DELEGATED APPLICATION REPORT

SITE ADDRESS: Abbey Gardens, 4-6 Abbey Street, Reading, RG1 3BA

APPLICATION NUMBER: PL/25/1175

PROPOSAL: Installation of roof space windows on the north, east and west elevations of the north block and north, south and west elevations of the central block and construction of a roof to enclose the plant area within part of the central block, all associated with the existing office use (Class E) (amended description).

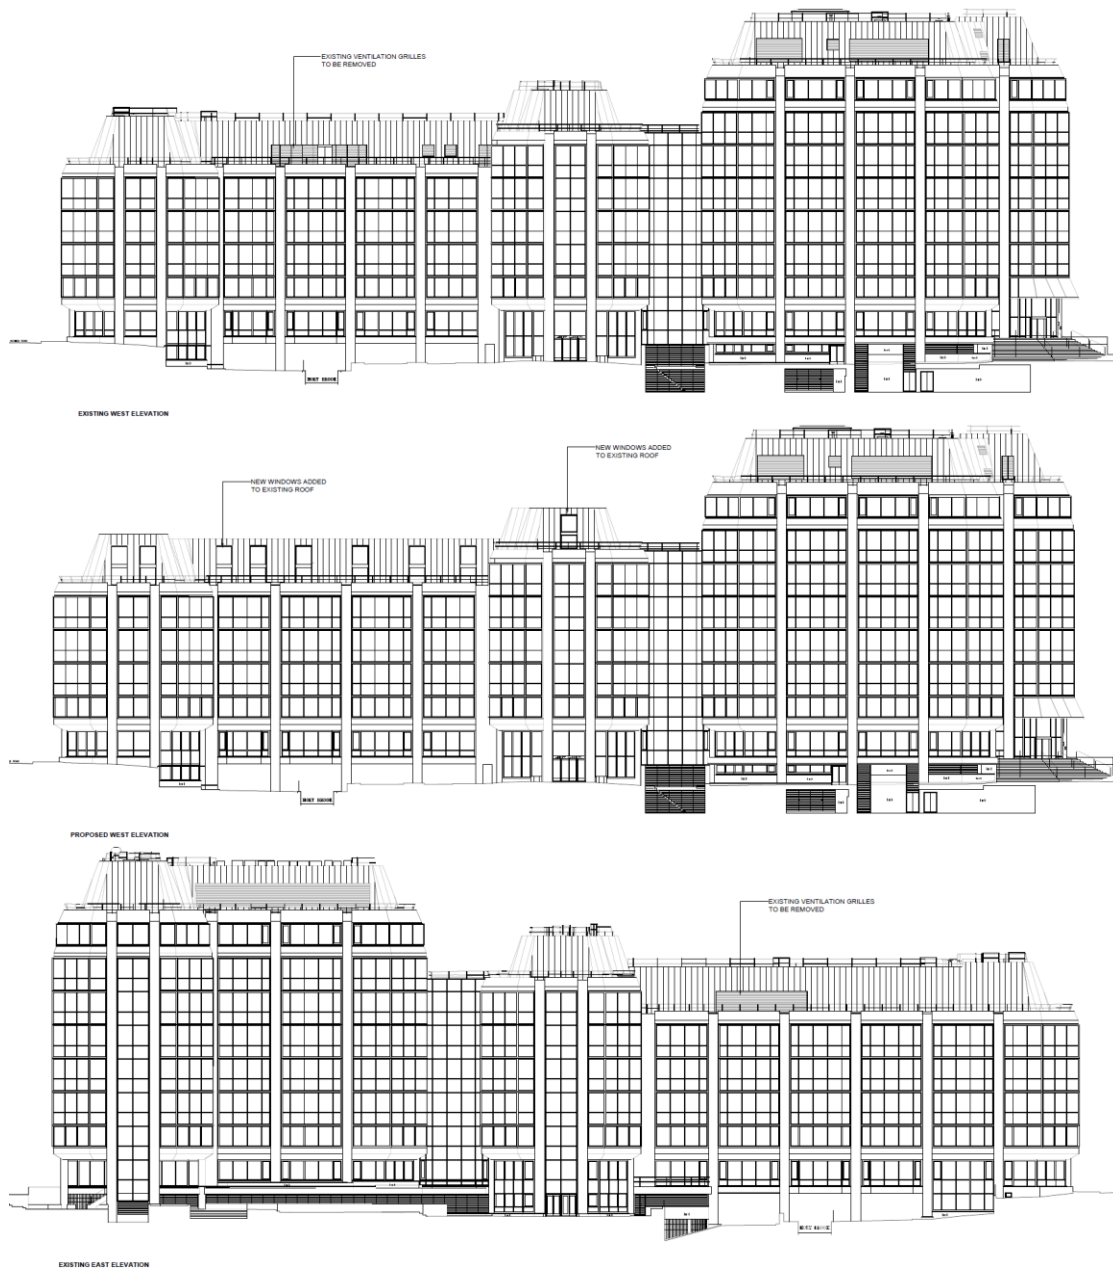
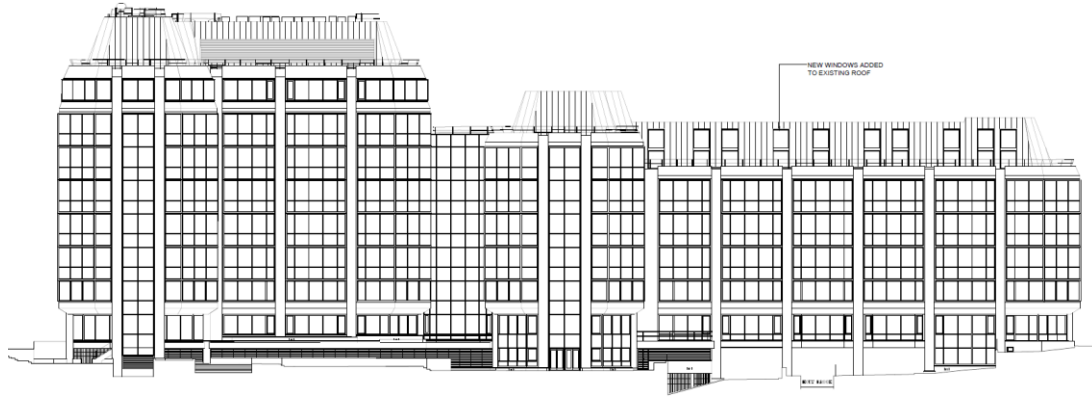
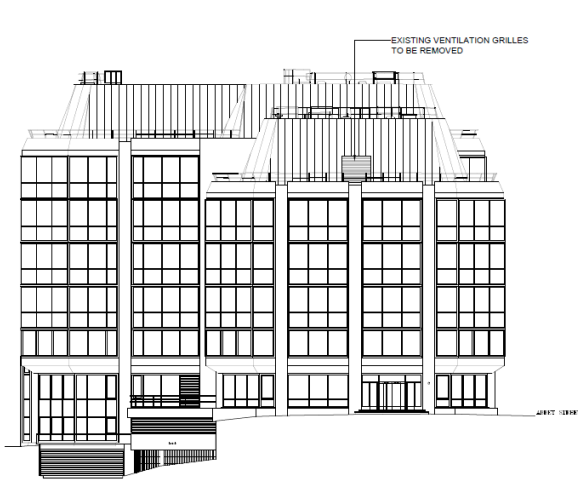
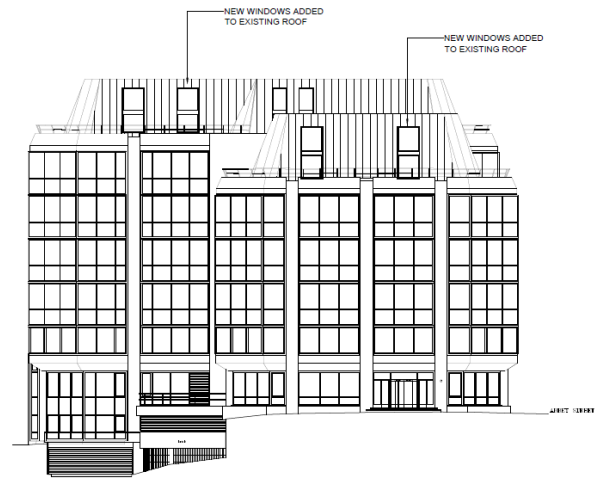
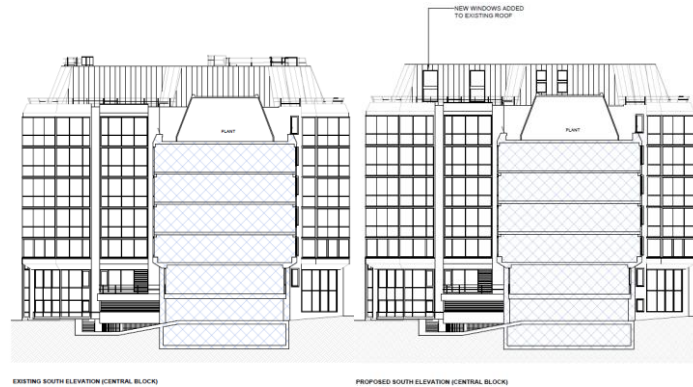
- 7.4 In support of the proposals the applicant has submitted a supporting statement and separate design statement, which explains that the double height roofspace, currently housing plant and associated equipment, is now redundant ahead of the anticipated future residential use. The roofspace, which is akin to a mansard in visual terms from public vantage points at ground level, also includes a series of existing ventilation grilles alongside the vertical standing seam metal cladding, which will be altered to align with the existing cladding appearance, as appropriate alongside the proposed windows. The result is minor additions in the context of the building as a whole, with the installation of the windows not compromising the overall character of the existing building, which is prominent in a number of long views (e.g. from the east along the River Kennet at this point). Roof level windows are a typical feature of buildings generally and in the area, with some nearby examples provided by the applicant in support of the proposals. The proposed windows are considered to align with the principles of Policies CC7 and CR2.

Above: Existing and proposed sections of the roofspace. Right: Existing roof level photograph.

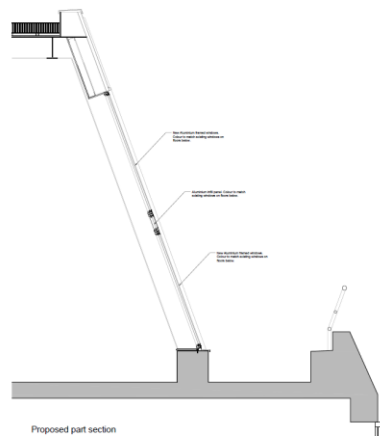
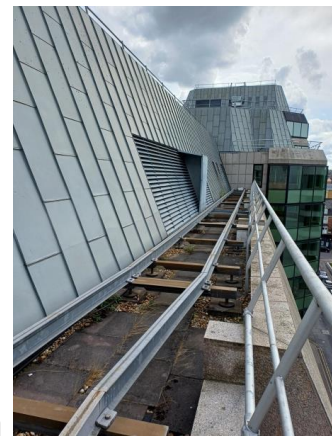
- 7.5 The windows themselves will be aluminium framed, with the colour to match existing windows on floors below. Such an approach is considered to bring continuity and coherency to the building. The section plan provided also shows the detail, with the windows being flush with the existing gently sloping roof form. No issues are raised with the detailed design of the windows, so a compliance condition will be included for matching materials to be used, as already indicated by the applicant.

3. The materials to be used in the construction of the external surfaces of this development shall be as specified on the plans and application form.

EXISTING SECTION (Central Block Roof)

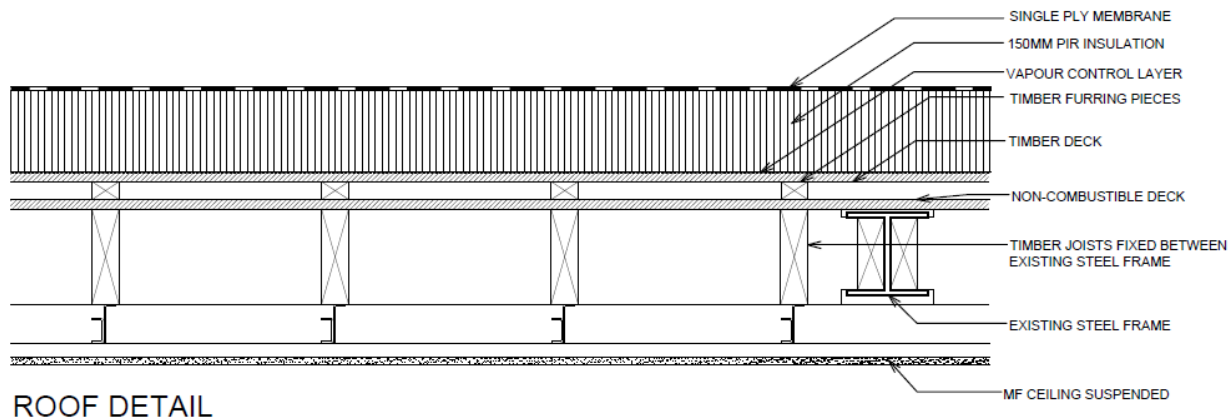
- 7.6 In terms of the enclosure of the currently open air plant area at part of the middle block, this is a simple addition, as shown in the section and detail shown below. This raises no design concerns, with the addition not readily visible in public vantage points at ground floor level. Again, this element of the proposals are considered to align with the principles of Policies CC7 and CR2.
